21-044AFDP – BALGRIFFIN MULTI-FAMILY CHIMNEY – 6138 TURVEY LOOP EAST

Request for review and approval of an Amended Final Development Plan to allow for an alteration to the architectural requirements for a condominium unit to permit the removal of a chimney.

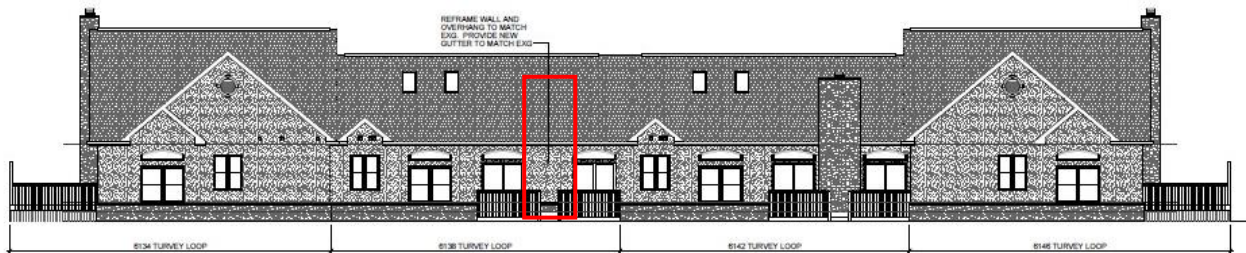
This request is to remove the existing chimney, due to structural issues, and replace it with the same adjacent stucco, as shown in the elevations below. The fireplace would be converted to an electric model.

In the course of this application, the Building Standards Division was consulted, and it was determined that it would be appropriate to support the chimney using mud jacking, permanent jacks, sistering the existing joists, or other supporting techniques, thus preserving the chimney. The proper foundation repairs would also avoid the necessity of trying to match materials that may be over 20 years old and paint that will also be older and naturally weathered. Should the chimney be removed as requested, the following items are of concern:

- Matching the existing stucco
 - Stucco texture is very difficult to match exactly
 - Patches often crack where they meet existing materials
- Matching the existing paint, which will have weathered

- Sherwin Williams paint in Quinoa (SW9102) is proposed. No color sample was provided.
 - An entire section of the building will need to be painted to avoid a patched appearance; this may involve painting parts of adjacent units

- Replacement of roofing and gutter materials at the chimney location, including gable and crickets at the chimney connection
 - GAF Timberline Weathered Wood is proposed. No sample was provided.

- No gutter information was provided.
 - Exact matches of materials may or may not be successful, based on age and weathering
- Replacement of the stone at the foundation

- The applicant has proposed to reuse the existing stone from the removed chimney. It is unclear that the old mortar can be successfully removed without damaging the stone itself

- The patched section may have straight edges (a saw cut) calling further attention to the patch.
